## Report to Planning and Environment Committee

**Subject:** Lambeth Health Organization Inc.  
(c/o Siv-ik Planning & Design Inc.)  
4366 Colonel Talbot Road  
City File: Z-9676, Ward 9  
Public Participation Meeting

**Date:** January 30, 2024

Figure 3. Concept Site Plan

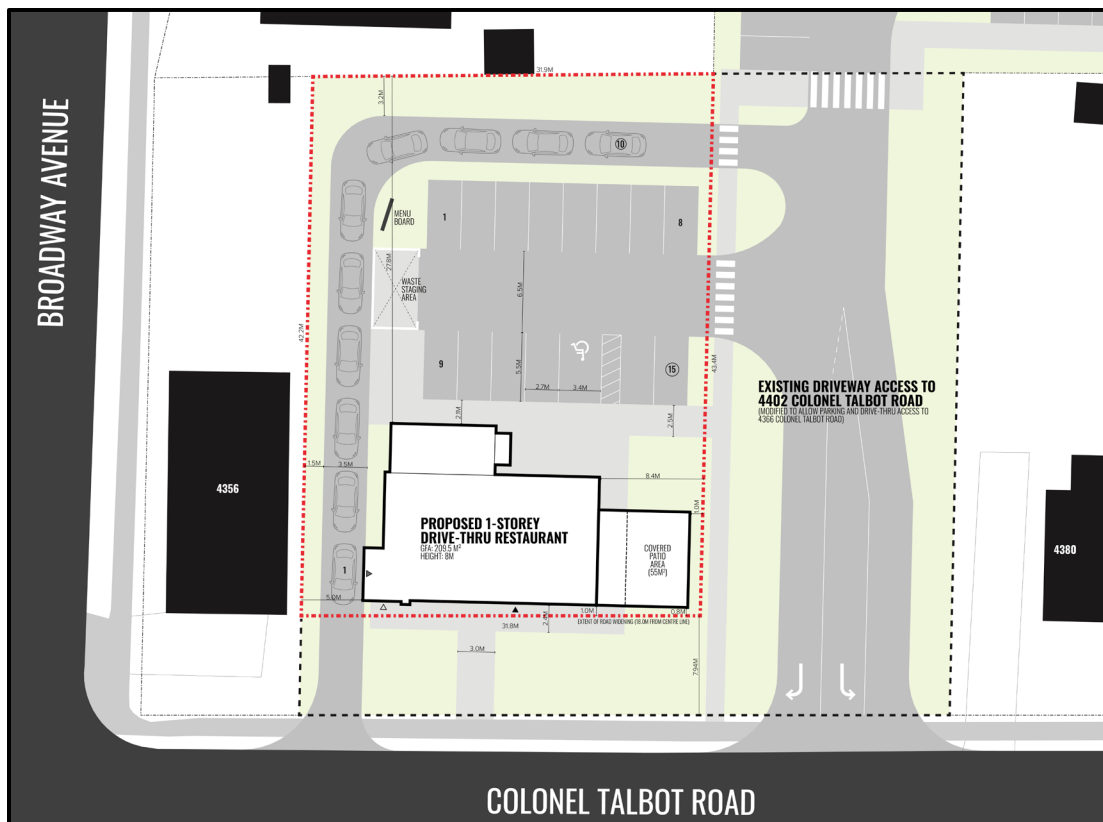
- A separate egress point for a drive-through is not supported by Transportation based on the Access Management Guidelines as per the policies of The London Plan. The applicant may consider a drive-through layout with access to/from the existing driveway.
- As noted at the time of Site Plan Consultation, the exit for the drive-through lane must be relocated to be internal to the site.

The City Council adopted Access Management Guidelines provide further detail. Section 1.3 states that direct access to an arterial road must be minimized, and therefore, all proposed driveways must be justified. In accordance with the Access Management Guidelines the preference of the City is for one driveway per development to an abutting arterial roadway. In this case, the proposal includes a main driveway as well as the drive-through exit onto Colonel Talbot Road. Additional driveway access to the arterial road network will be subject to special considerations such as traffic analysis justifying the need for additional access to improve safety, flow and/or circulation and shall meet the spacing requirements. Said spacing requirements are outlined in Section 1.4.3 in which strict applications of traffic engineering criteria may place desirable spacing requirements at 150 metres along an arterial roadway. This type of spacing, however, is mostly unachievable in many urban and suburban environments in which typically a spacing of 30 – 60 metres is used along an arterial or primary collector roadway. In this case, the separate egress point for the drive-through does not provide the desirable or typical spacing (a spacing of 30-60 metres is used along an arterial or primary collector roadway whereas roughly 13 metres and 26 metres are being proposed) between the existing access point at 4366 Colonel Talbot Road and the intersection of Colonel Talbot Road and Broadway Avenue and is therefore not supported by Staff.

As proposed, the drive-through exit directly onto Colonel Talbot Road does not mitigate for potential adverse impacts with regards to traffic, safety and access management (TLP, 1578\_6). Additionally, the drive-through exit does not promote a pedestrian-oriented main street environment in accordance with the intent of the Main Street Lambeth South policies of the Southwest Area Secondary Plan which state that the primary mode of transportation will be by walking or cycling (20.5.8.1.v. a). Rather, the drive-through facility compromises pedestrian safety as well as traffic safety.

- As noted at the time of Site Plan Consultation, the exit for the drive-through lane must be relocated to be internal to the site.

- A separate egress point for a drive-through is not supported by Transportation based on the Access Management Guidelines as per the policies of The London Plan.
- The applicant may consider a drive-through layout with access to/from the existing driveway.
- As per Zoning By-Law Z1, the site is exempt for minimum parking standards.
- Providing appropriate facilities for walking and cycling should be considered the priority, consistent with the Southwest Area Plan:
  - [Southwest Area Secondary Plan \(london.ca\)](#)
    - 20.5.8.2 Main Street Lambeth South
      - iv) Transportation
        - a) It is intended that the primary mode of transportation within the Village Community will be by walking or cycling.

- (c) The Site Plan Approval Authority **BE REQUESTED** to consider the following design issues through the site plan process:
  - i. Relocate the exit of the drive-through lane internal to the site.

- ii. A landscape buffer between a drive-through lane and adjacent properties of 3.0 metre to the north and 1.5 metres to the east shall be provided.

The recommended action to refuse the requested special provision that a single-lane drive-through exit shall be permitted onto Colonel Talbot Road will thereby require the exit of the drive-through lane to be relocated fully internal to the site at time of site plan application. Should the drive-through exit onto Colonel Talbot Road be approved, 10 stacking spaces would be permitted.
